APPLE VALLEY PLANNING COMMISSION PUBLIC

AGENDA

Planning Commission agenda report for June 28, 2023: Preliminary Plat for Monson 20 Acre subdivision with 2 lots. (updated 6/27/2023)

Planning Commission agenda report for June 28, 2023: Preliminary Plat for Crimson Peaks subdivision.

NORTH LOTS IN PRELIMINARY PLAT FOR:
CRIMSON PEAKS
LOCATED IN SECTION 19, T42S, R11W, S.L.B.#M.
APPLE VALLEY, WASHINGTON COUNTY, UTAH

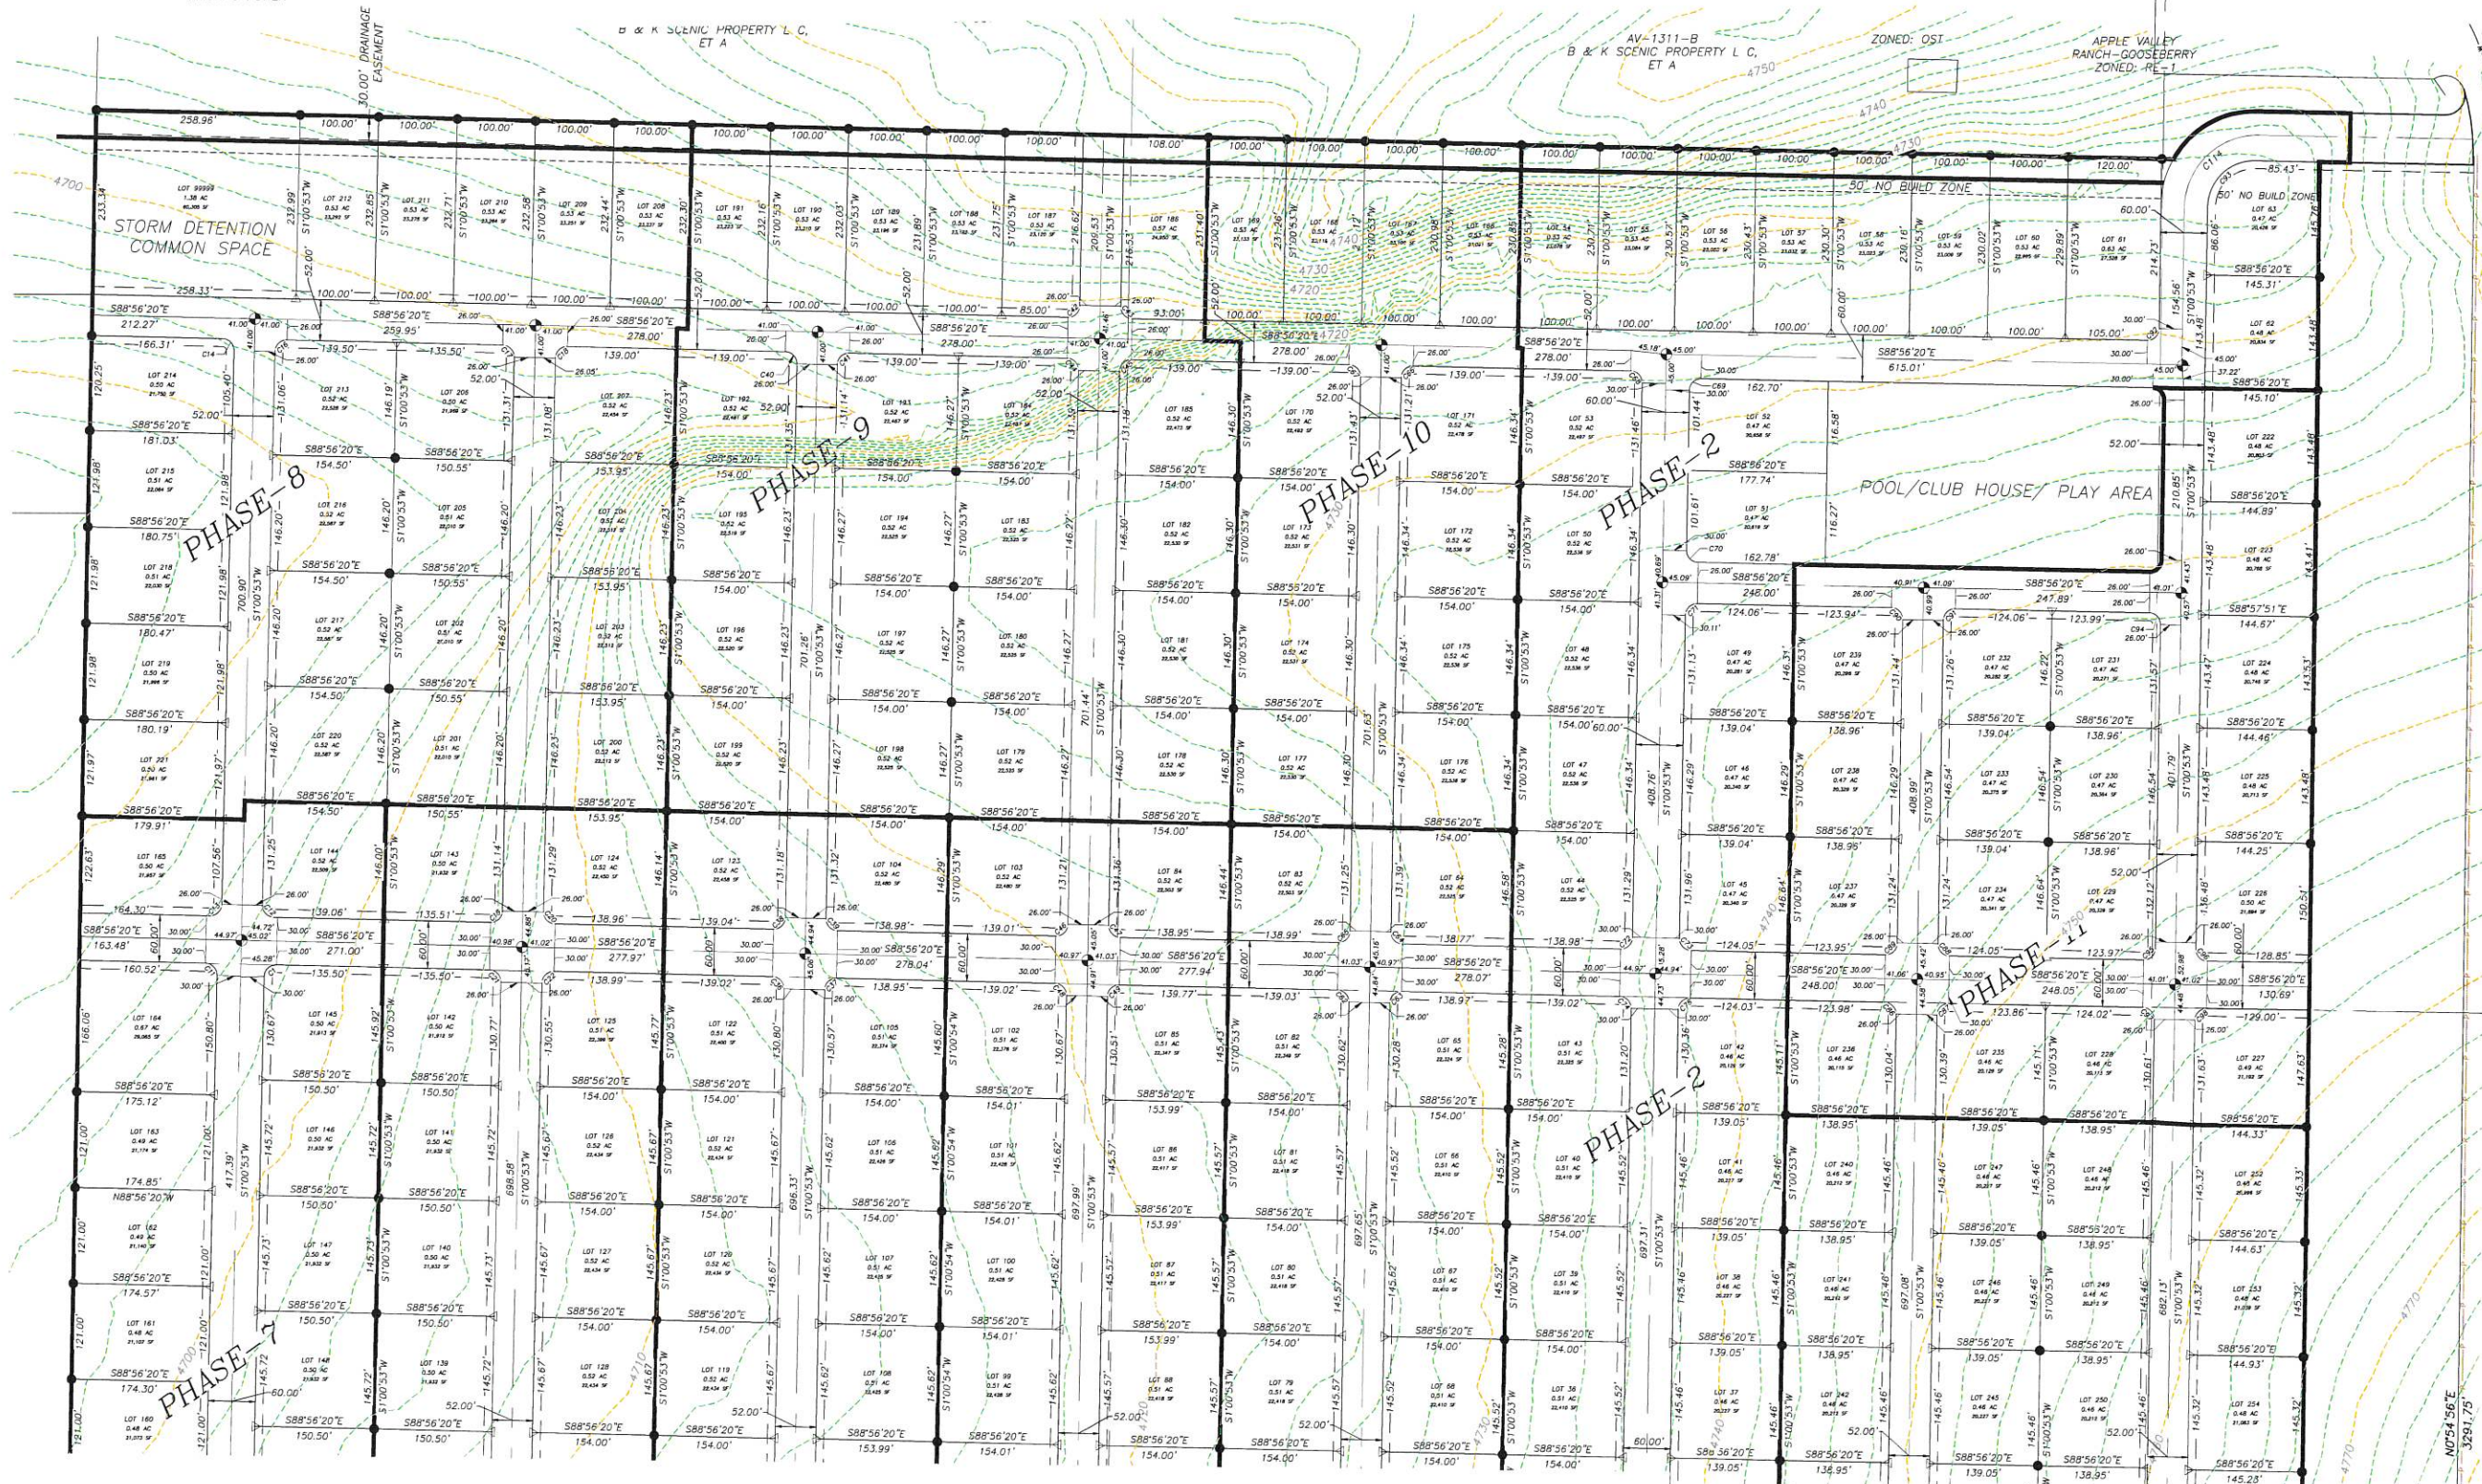
Staff Comments: Preliminary Plat is ready for approval subject to approval of a zone change on 12.47 acres located in a portion of the proposed subdivision, and also subject to approval of a wastewater disposal plan by Ash Creek SS District. The present water commitment is for only 31 lots, and not for the entire project of 262 lots. The applicant should work with both the Ash Creek SSD and the Big Plains Water SSD to obtain approvals for the water and sewer service for the entire proposed project.

Show all turning radius are a minimum of 35 feet inside and 55 feet outside face of curb. (2018 IFC 503.2.4)

Water/utility development plans shall show fire hydrant locations.
